**SOLICITATION AMENDMENT**  
**MODIFICATION DE L'INVITATION**

<b>Title - Sujet</b> Construction Services	
<b>Solicitation No. - N° de l'invitation</b> EZ899-152249/A	<b>Amendment No. - N° modif.</b> 004
<b>Client Reference No. - N° de référence du client</b>	<b>Date</b> 2015-04-17
<b>GETS Reference No. - N° de référence de SEAG</b> PW-\$PWY-019-7491	
<b>File No. - N° de dossier</b> PWY-4-37355 (019)	<b>CCC No./N° CCC - FMS No./N° VME</b>
<b>Solicitation Closes - L'invitation prend fin at - à 02:00 PM on - le 2015-04-30</b>	<b>Time Zone</b> Fuseau horaire Pacific Daylight Saving Time PDT
<b>F.O.B. - F.A.B.</b> <b>Plant-Usine:</b> <input type="checkbox"/> <b>Destination:</b> <input checked="" type="checkbox"/> <b>Other-Autre:</b> <input type="checkbox"/>	
<b>Address Enquiries to: - Adresser toutes questions à:</b> Ngan, Ken (PWY)	<b>Buyer Id - Id de l'acheteur</b> pwy019
<b>Telephone No. - N° de téléphone</b> (604) 658-2755 ( )	<b>FAX No. - N° de FAX</b> (604) 775-6633

Addendum #002

Tender A – Pleasant Camp Port of Entry

### **2.1 TREATED WATER STORAGE TANK TK-1.4**

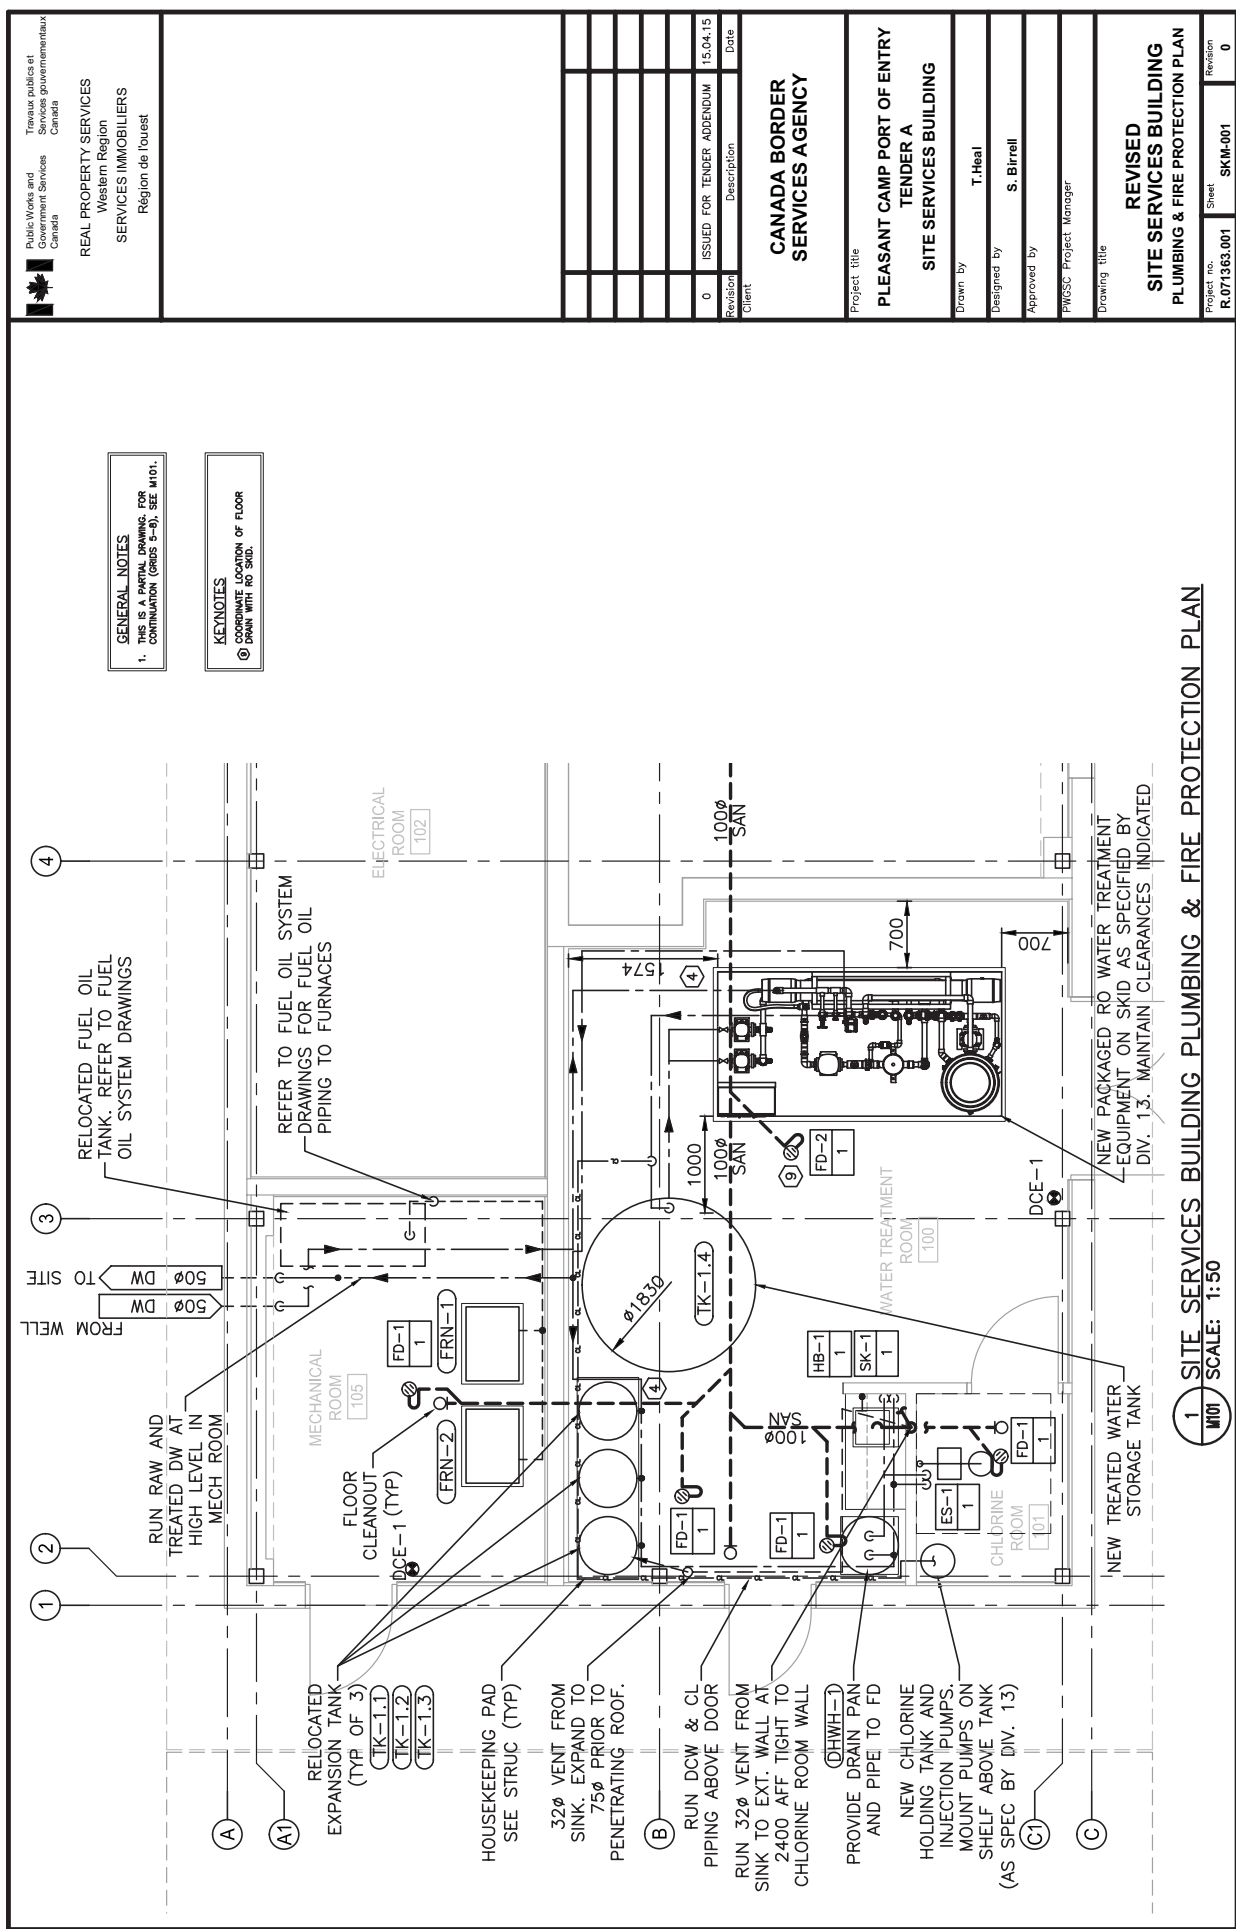
- .1 Section 13 50 20 Add specification attached. See SKM-003 P&ID attached.
- .2 Section 13 50 40 Delete Tender specification. Chemical feed system is now specified as part of the treatment skid in Section 135020.
- .3 Section 22 36 00 Add new treated water storage tank TK-1.4 spec (attached).

- 1. Drawing M101, plan 1: Revise layout to accommodate RO treatment system skid and new tank TK-1.4 as shown on attached sketch SKM-001 including:
  - a. Delete TK-1.4 and replace with new treated water storage tank TK-1.4 bolted to the floor

- a. Delete TK-1.4 and provide new TK-1.4 Treated Water Storage Tank as per specifications.
- b. TK-1.5 and TK-1.6 to be turned over to owner
- c. Delete TK-1.7 (chlorine tank to be provided by Division 13 as part of RO Water Treatment package)

Sheet  
SKM-002

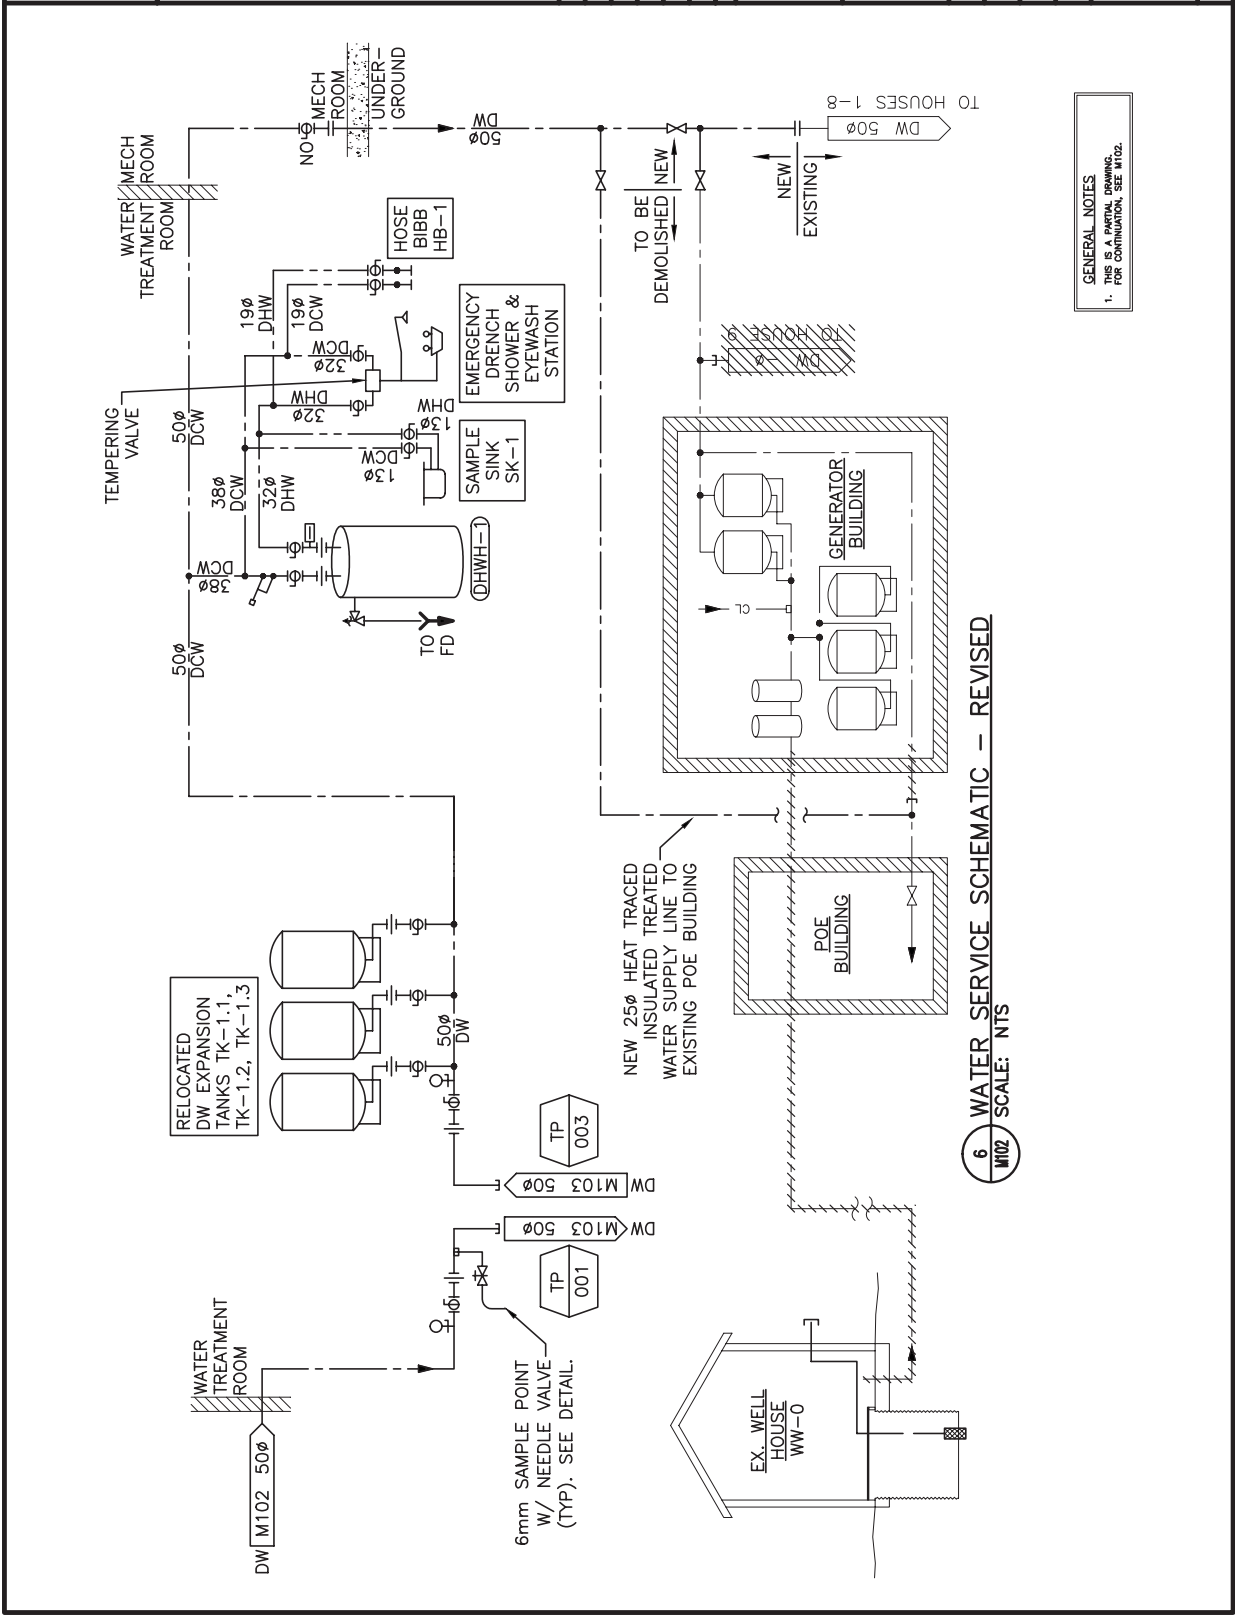
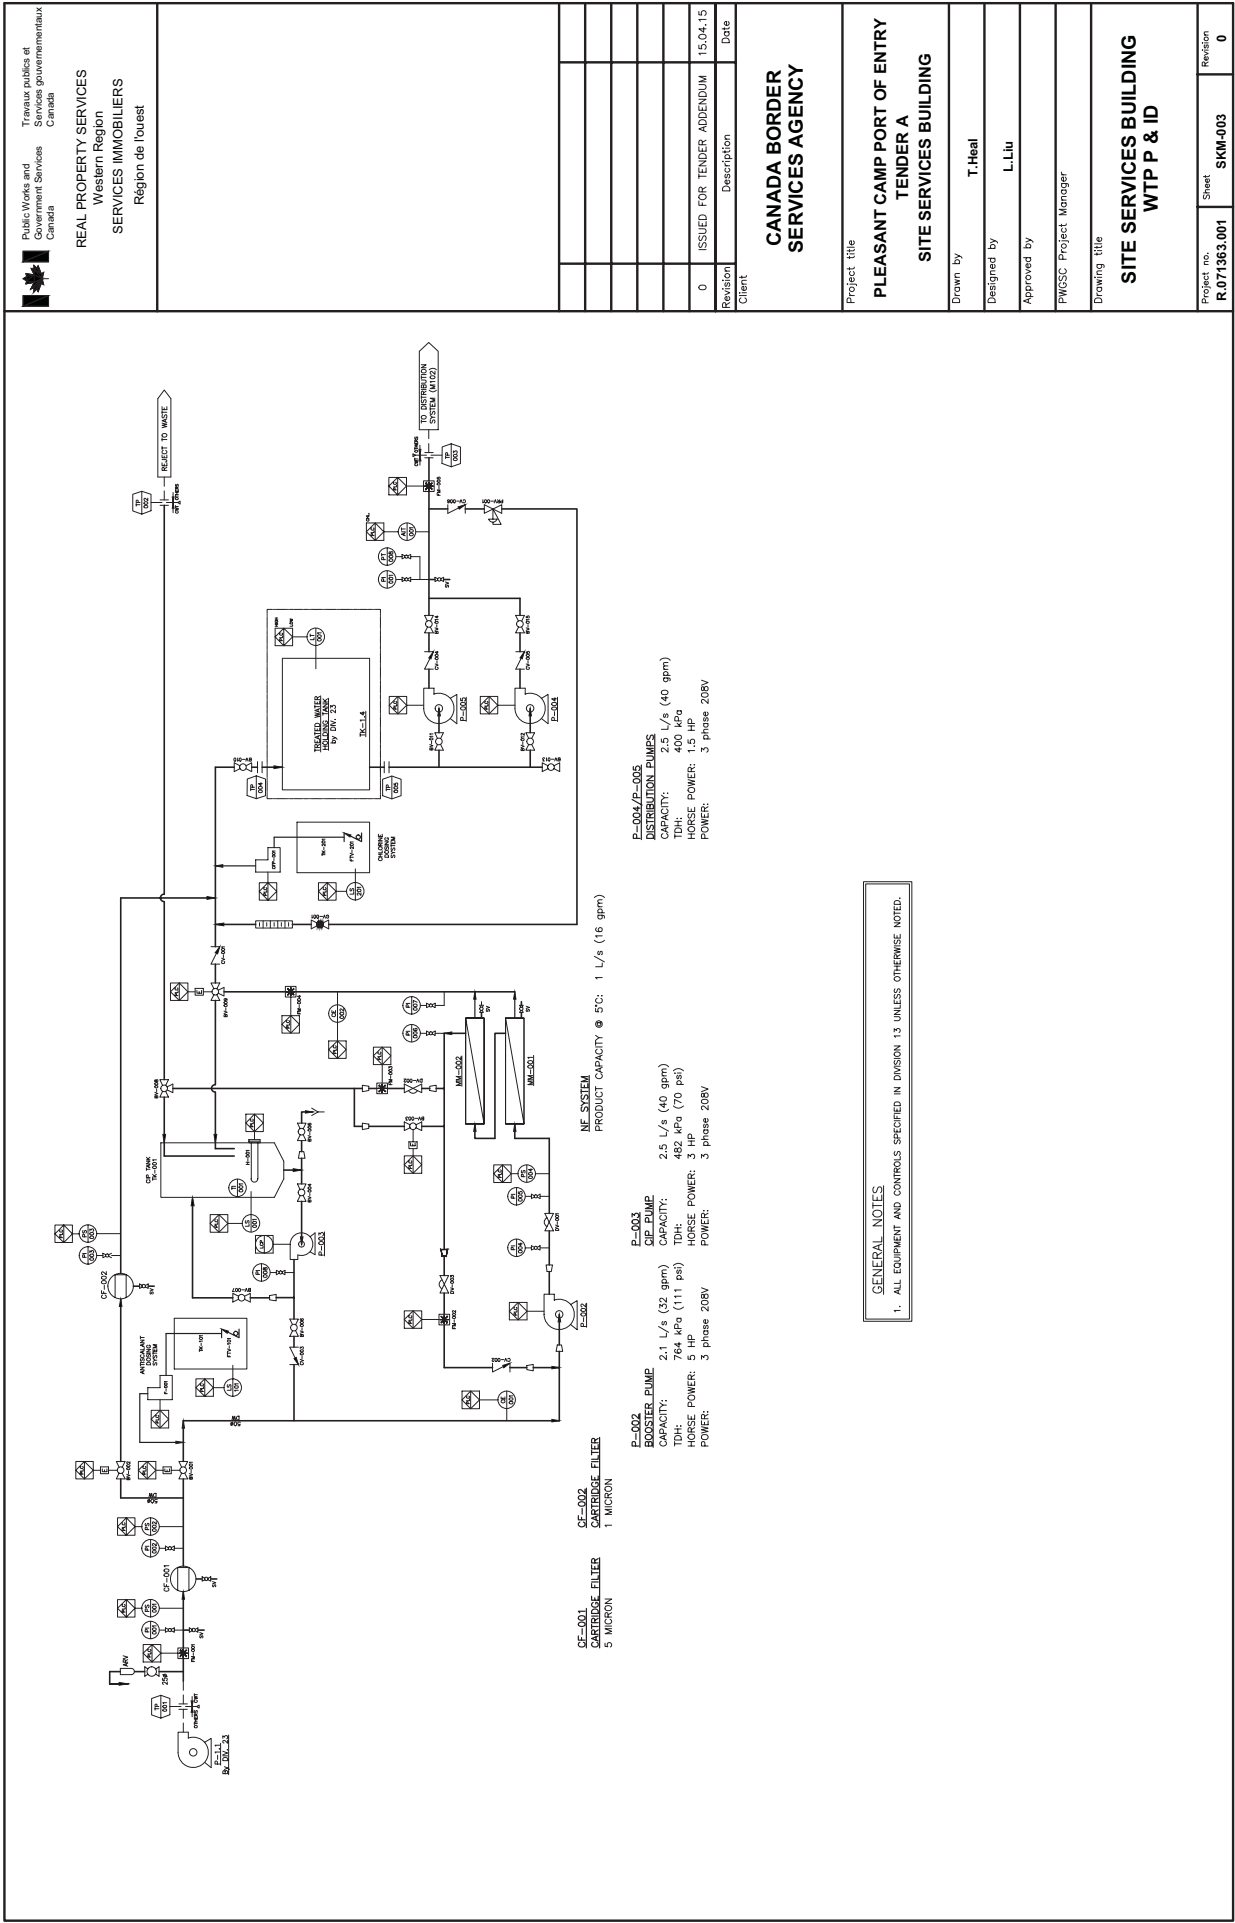
- i. Revise floor drain adjacent to RO Water Treatment Skid to FD-2 and coordinate location with Skid.
- 2. Drawing M102, schematic 6: Revise per attached sketch SKM-002.

- 3. Drawing M102, schematic 6: Revise per attached sketch SKM-002.
- 4. Drawing M701, Plumbing Fixtures Schedule:
  - a. Add FD-2; Description = Funnel Floor Drain, San diameter = 100mm.
